55 BAC NOTE: Applies to all Beech Aerocenter planes with the S550 Klipvolt Suppressor installed, per Beech Technical Support in 2005. **No. 0614-351**
ATA Code 24-30

SUBJECT: ELECTRICAL - NOSE SECTION - REMOVAL OF S550 KLIPVOLT SUPPRESSOR FROM BATTERY MASTER RELAY AND INSTALLATION OF 1N4005 DIODE

Service Instructions No. 0614-351

Wiring Diagram

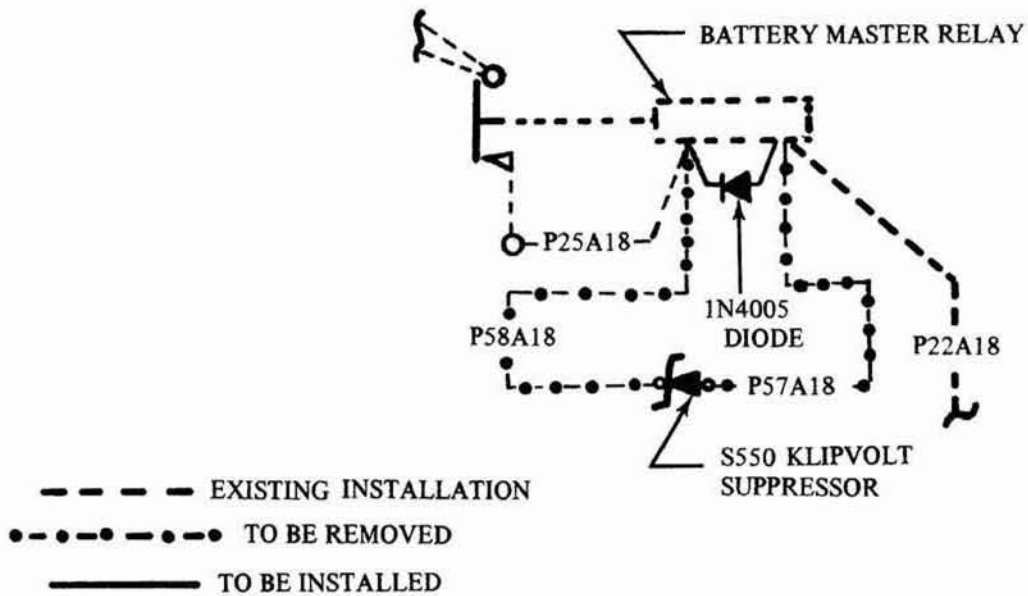
DESCRIPTION: The existing S550 Klipvolt suppressor, wire P57A18 and wire P58A18 should be removed and an 1N4005 diode installed.

2. Use Military Standard, MIL-I-631, sleeving to insulate the 1N4005 diode leads. Butt the sleeving against the diode and leave approximately 1/4 inch at the end of each lead bare.
3. Remove the S550 Klipvolt suppressor lead P58A18 from the battery master relay terminal and connect the 1N4005 diode lead, at the banded end of the diode, in its place.
4. Remove wire P57A18 and connect the remaining lead of the 1N4005 diode in its place. Remove the S550 Klipvolt suppressor and leads. (Refer to the illustration for wiring diagram.)
5. Reconnect the battery connectors and secure the nose baggage compartment door.
